Chevy Chase View
Request for Specimen Tree Variance
Preliminary Plan 120180160

RE: Chevy Chase View, ePlan 120180160, NRI/FSD application accepted on 11/9/2017

Re: **COMBINED STORMWATER MANAGEMENT
CONCEPT/SITE DEVELOPMENT
STORMWATER MANAGEMENT PLAN**
for Chevy Chase View
4025 Saul Road
PP# 120180160
SM File #: 283664
Tract Size/Zone: 1.15 ac./R-90
Total Concept Area: 1.15 ac/ 49873 sf
Lots/Block: Tax Map 342 parcel
to be subdivided into Lots 101 - 103/Block D and
Outlot A
Watershed: Lower Rock Creek

RE: Preliminary Plan Letter-**AMENDED**
Preliminary Plan No. 120180160
Chevy Chase View

FIRE ACCESS PLAN

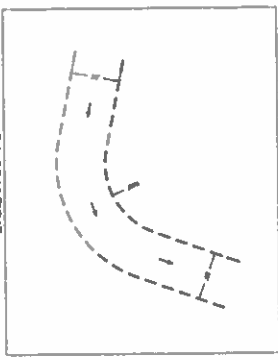
PLAN APPROVED

1. Review based only upon information contained on the plan submitted 02-Jul-18. Review and approval does not cover manufacturing installation resulting from errors, omissions, or failure to clearly indicate conditions on this plan.
2. Correction of manufacturing installation will be required upon inspection and service of notice of violation to a party responsible for the property.

***** Minimum 15 foot BRI *****
